HISTORIC DISTRICT REVIEW BOARD MEETING AGENDA

Title: HDRB #23-013; Window replacement; 743 Florence Place

Title: HDRB #23-014; Alteration; 951 Locust Street

SCALE:	As indicated
SHEET TITLE:	FRONT & REAR ELEVATIONS
SHEET NUMBER:	A2.0

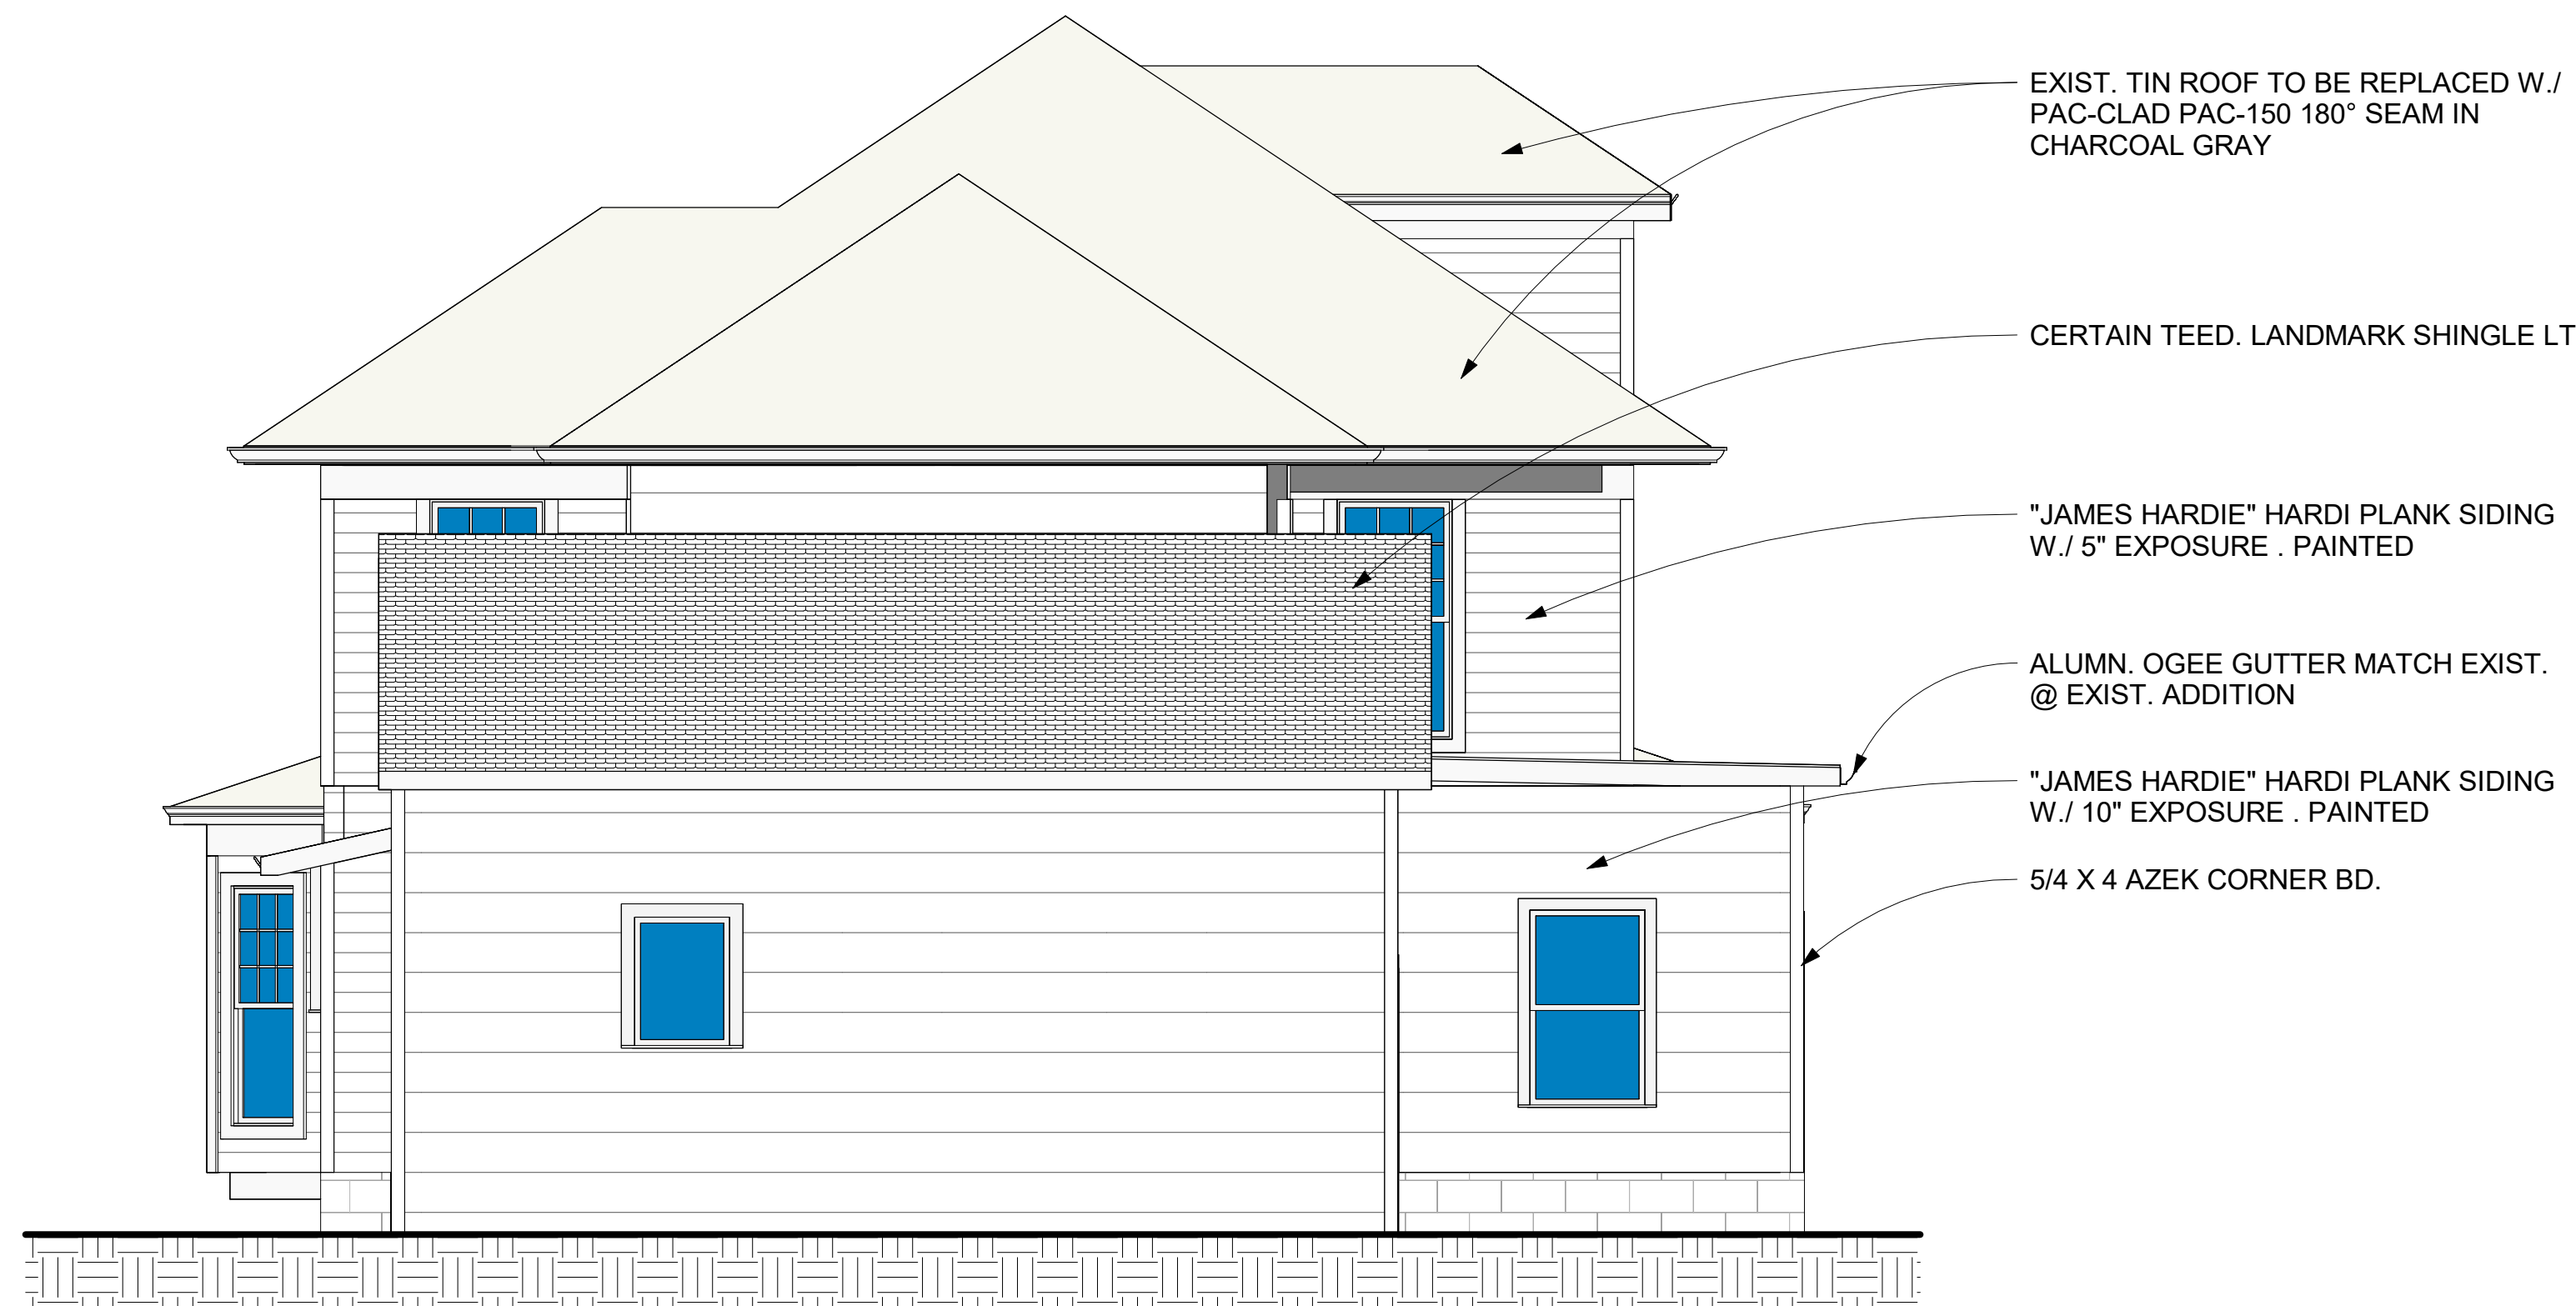
This application proposes an alternative window to those that were previously approved. The proposed windows were installed prior to this application. The applicant has explained that the windows were installed under the misconception that they were the correct windows and had been approved by the Board in HDRB #22-001. The originally approved windows were fiberglass Marvin Elevate, double-hung sash windows with simulated divided lights matching the pattern of the original windows (see attachment #2 for the previously approved specs sheet). The proposed windows are the same material and type but do not feature simulated divided lights.

The applicant has provided images of the installed proposed windows and referenced the originally proposed specifications sheet (attachment #2) for all aspects of the windows except the muntin type. As mentioned, the only difference between the previously approved windows and the proposed windows is the absence of integrated muntins/grills in the proposed windows.

Window Muntins: For replacement windows with multiple panes of glass, simulated divided lights with dimensional muntins or grills on the exterior of the glass should be used.	Does not meet	The installed windows feature flat interior light divisions which are completely contained within the panels of glass as opposed to dimensional muntins which are positioned on the exterior of the window pane.

5. **Alternative Options.** Per the Guidelines cited above the proposed windows are not in compliance. However, there may be other options without wholesale replacement of the existing windows. One option that might be considered is replacing the upper sashes (those that feature muntins) on windows on the original portions of the house that are visible from the right of way with sashes that have simulated divided lites. This would enable the retention of the existing window frame and bottom sash while bringing the windows into compliance with the Guidelines. The Board may wish to discuss this with the applicant.
6. **Staff Recommendation.** Staff is withholding a recommendation to allow for coordination and discussion with the applicant with the hope that a solution can be attained that will both meet the Guidelines and accommodate the needs of the applicant.

Fifth Street-Facing
Side of Home. New
Dormers will match
the two seen here.

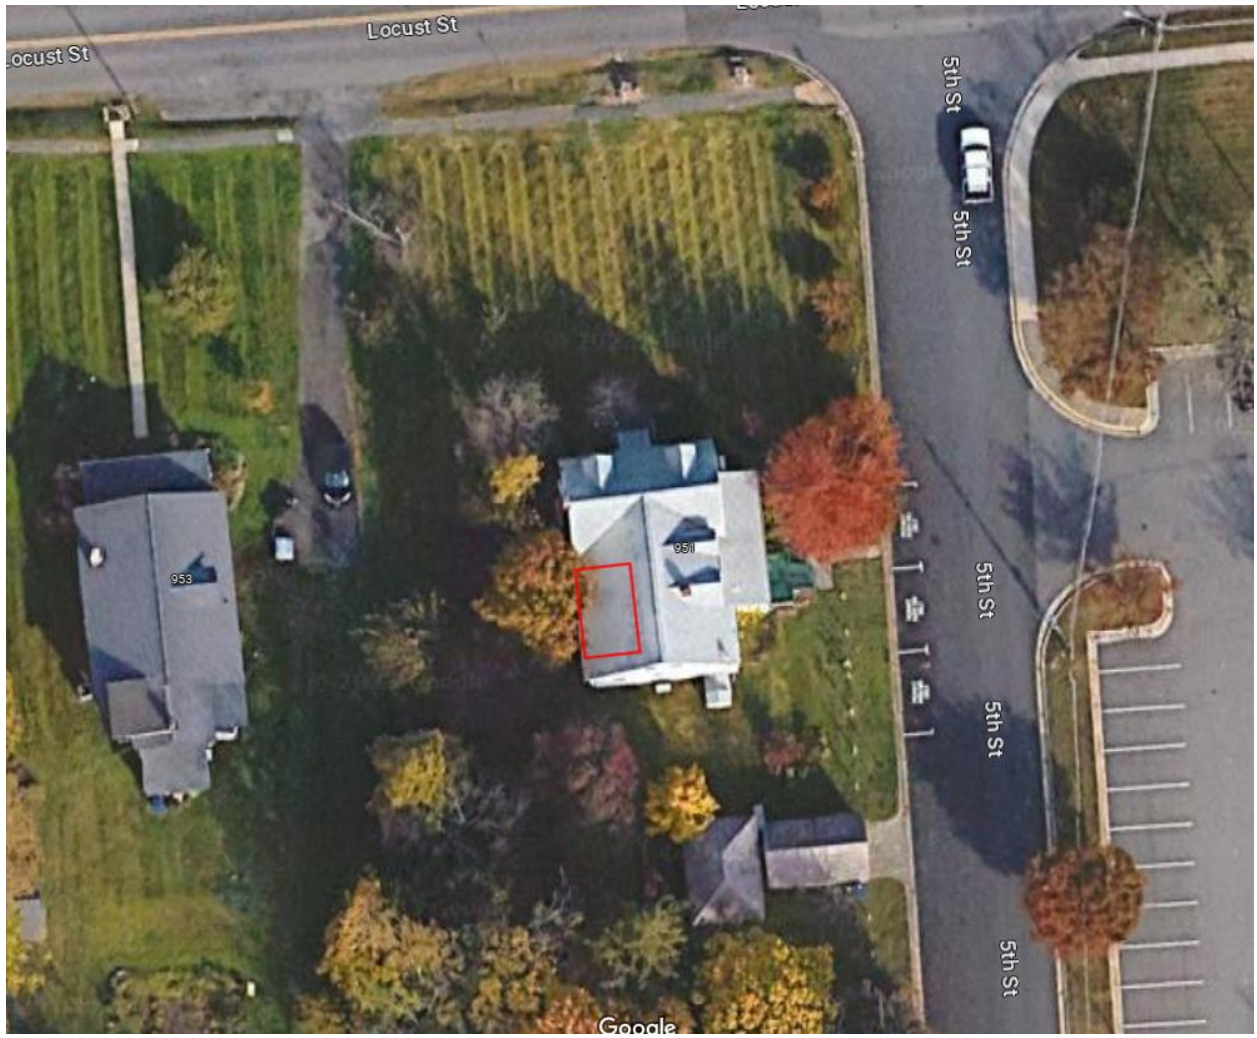
3. **Dormer addition.** The Guidelines allow for the addition of new dormers under certain circumstances and provided considerations are made for if/how the new element affects historic fabric, whether it changes the massing of a building, and where it is placed on the building. The proposed dormer is situated on a roof that is non-historic and is on a secondary elevation, recessed from the primary front elevation, and minimally visible from the right of way. The proposed dormer is also compatible in style with the existing dormers and is differentiated so that it does not appear indiscernible from the historic front dormers.

951 LOCUST ST. - SIDE DORMER 1000-1000
 PLANS BY: ANDREW GANNON, 2023

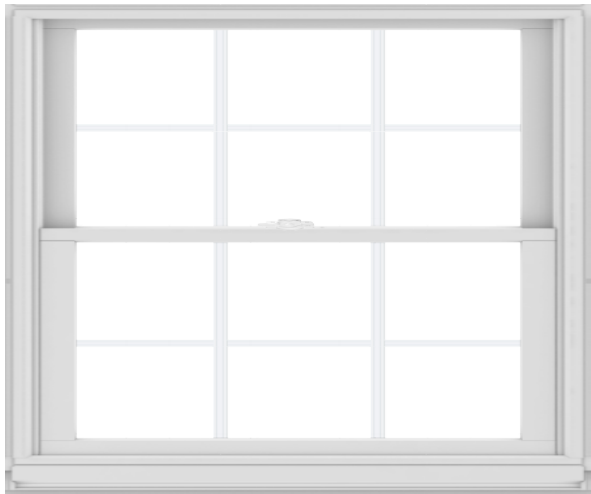
been approved by the board to replace other types of roofing. Since the application does not include materials specifications, additional clarification should be sought before a full review of this material can be completed. Staff is requesting additional specifications for the standing seam metal roof, including panel width, seam height, and material details.

5. **Windows.** The applicant is proposing three new windows for the dormer which are Anderson 400 Series Tilt Wash Double Hung Windows. This window has a vinyl exterior which is not considered by the Guidelines to be an appropriate window for structures within the historic district. Alternative materials such as fiberglass and aluminum are materials that have been found to be historically compatible with projects in the past. Staff will work with the applicant to address this concern.

6. **Siding.** The application states that the siding for the dormer will be Hardie Plank lap siding. This has been considered an appropriate siding for contributing structures within the district and meets the Guidelines for alternative materials. Staff seeks clarification regarding the reveal size and the finish (textured vs smooth) as these were not specified in the materials provided. Faux wood texture is not considered an appropriate finish for siding on contributing structures.

7. Requested information. Staff is requesting the following additional information or alterations prior to making a recommendation to the Board:
 - Clarification regarding standing seam metal roof panel width and seam height

- Clarification regarding the finish/surface texture of the proposed siding.
 - New proposed windows that do not feature a vinyl exterior.
8. **Staff Recommendation.** Staff is overall supportive of this project but is withholding a recommendation pending further information from the applicant.
